UNITED STATES PATENT AND TRADEMARK OFFICE

APPLICATION NO.	FILING DATE	FIRST NAMED INVENTOR	ATTORNEY DOCKET NO.	CONFIRMATION NO.
10/599,990	10/17/2006	Keith Baker	NL 040413	7915

Office Action Summary	Application No. 10/599,990	Applicant(s) BAKER, KEITH	
	Examiner Nathan A. Danielsen	Art Unit 2627

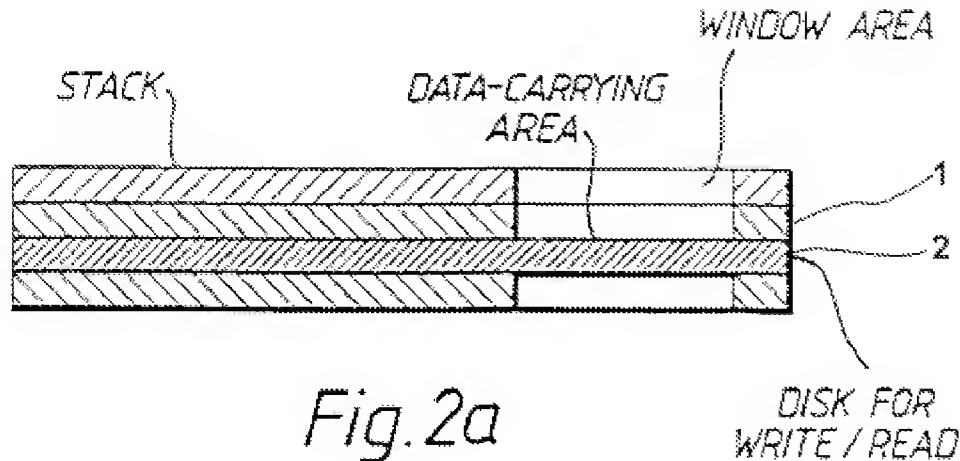
Regarding claims 1 and 10, Gudesen discloses an optical data storage medium (figure 2) comprising:

a first disc (element 1 in figure 2a, as shown on the next page) and a second disc (element 2 in figure 2a, as shown on the next page) both having an access surface (the surface of element 2 exposed to the optical read/write device of col. 5, line 67 through col. 6, line 1 on the side of the data carrying area from which light is irradiated by the optical read/write device) and a storage layer covered by the access surface (col. 6, lines 25-27), wherein the storage layer is adapted to be accessed by a laser beam via the access surface (implied by the structure disclosed in col. 6, lines 30-39 in that “high area density for the storage” would require the use of “sharp focusing of a laser beam” (see col. 1, line 65 through col. 2, line 2)), characterized in that the first disc and the second disc are adapted to be attached to each other in such a way that the access surface of the first disc covers the access surface of the second disc (the surface of element 2 “covers” the surface of element 1, as shown on the next page, where “cover” has been interpreted to mean “to hide from view; screen”
